Access Compliance Report

Public Rights-of-Way (Curb Ramps)

Intersection ID: 48160	Main Street: NORTHLAKE CENTRE PY	Cross Street: N/A	Location: NE
ADA ID: 3495B7333E70	Ramp Type: Perp	Initial Pass/Fail: Fail	Overall Compliance: No
			Severity Score: 10

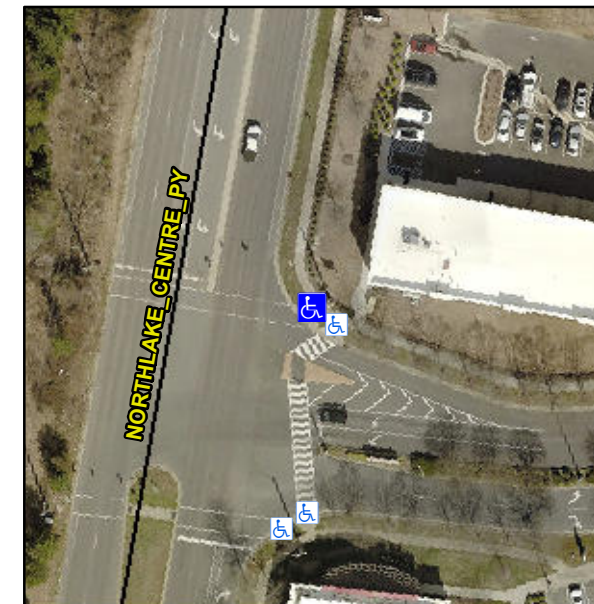
Not Found, R304.5.1, R304.5.3

Compliance	Description	Data	Compliance	Description	Data
N/A	Ramp Length (in)	97.0	Yes	Ramp Slope (%)	7.1
No	Ramp Width (in)	44.5	No	Ramp XSlope (%)	2.2
N/A	Flare Type LT	N/A	N/A	Flare Type RT	N/A
N/A	Flare Slope LT (%)	N/A	N/A	Flare Slope RT (%)	N/A
N/A	Flare Traversable LT?	N/A	N/A	Flare Traversable RT?	N/A
N/A	Landing Length (in)	N/A	N/A	DWS Provided?	N/A
N/A	Landing Width (in)	N/A	N/A	DWS Contrast?	N/A
N/A	Landing Slope (%)	N/A	N/A	DWS Length (in)	N/A
N/A	Landing X Slope (%)	N/A	N/A	DWS Full Width?	N/A
N/A	Landing Curb? (Y/N)	N/A	N/A	DWS Offset (in)	N/A
N/A	Shared Landing?	N/A			
N/A	Gutter Ponding?	N/A	N/A	Gutter Slope (%)	N/A
N/A	Gutter Lip Ht (in)	N/A	N/A	Gutter X Slope (%)	N/A
N/A	Painted X Walk1?	Yes	N/A	Painted X Walk2?	N/A
	X Walk 1 Direction	To W		X Walk 2 Direction	N/A
N/A	X Walk 1 Width (in)	112.0	N/A	X Walk 2 Width (in)	N/A
	X Walk 1 Slope (%)	2.4		X Walk 2 Slope (%)	N/A
	X Walk 1 X Slope (%)	0.8		X Walk 2 X Slope (%)	N/A

Remove & Replace Entire Ramp.
